GOVERNMENT OF THE DISTRICT OF COLUMBIA DEPARTMENT OF CONSUMER AND REGULATORY AFFAIRS

OFFICE OF THE ZONING ADMINISTRATOR

Re: 3661 Morrison St NW – Side Yard Determination

Attachment – Proposed Site Plan

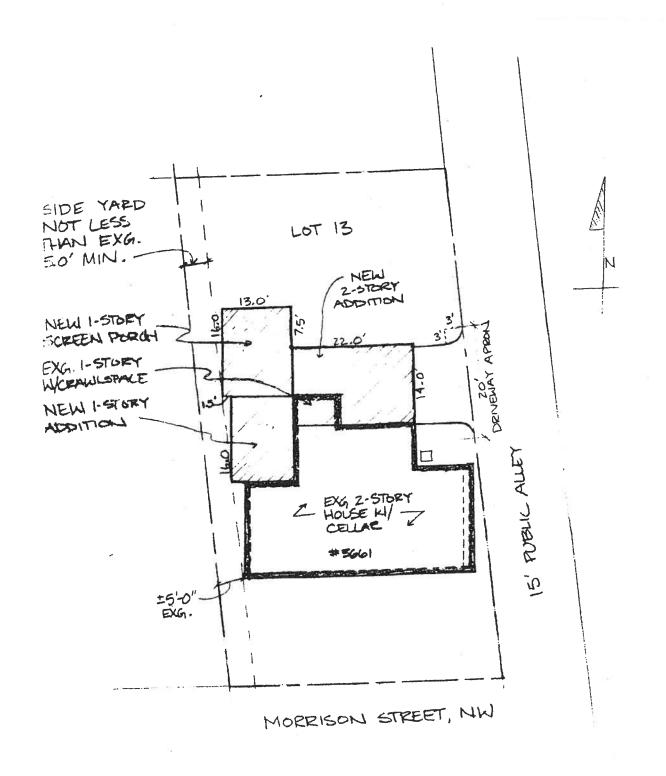
This letter will confirm the substance of my review of your letter of November 29, 2011 concerning the above-referenced Property. For reference, the Property is located in Square 1998, Lot 13, for which your firm is currently designing an addition to the existing single family residence located there. The subject property is located in an R-1-B zone. You provided me a proposed site plan (see attachment) showing a proposed addition along the rear of the house which extends out from the existing structure, in accordance with 11 DCMR 405.8.

That section permits additions to buildings with a non-conforming side yard of 5 feet [where 8 feet is normally required] as long as the addition does not decrease the width of the existing side yard, and the addition itself is set back a minimum of five (5) feet. Also, your client wishes to add a 1-story screened porch which will meet the minimum 5 foot setback.

I have reviewed the attached site plan and found that the project would conform with the relevant yard setback requirements. As long as the total building area does not exceed the maximum 40% lot occupancy limitation, the plan complies with the applicable zoning regulations.

Accordingly, when you file the plans for a building permit, I will approve drawings that are consistent with the site plan attached to this letter. Please let me know if you have any further questions.
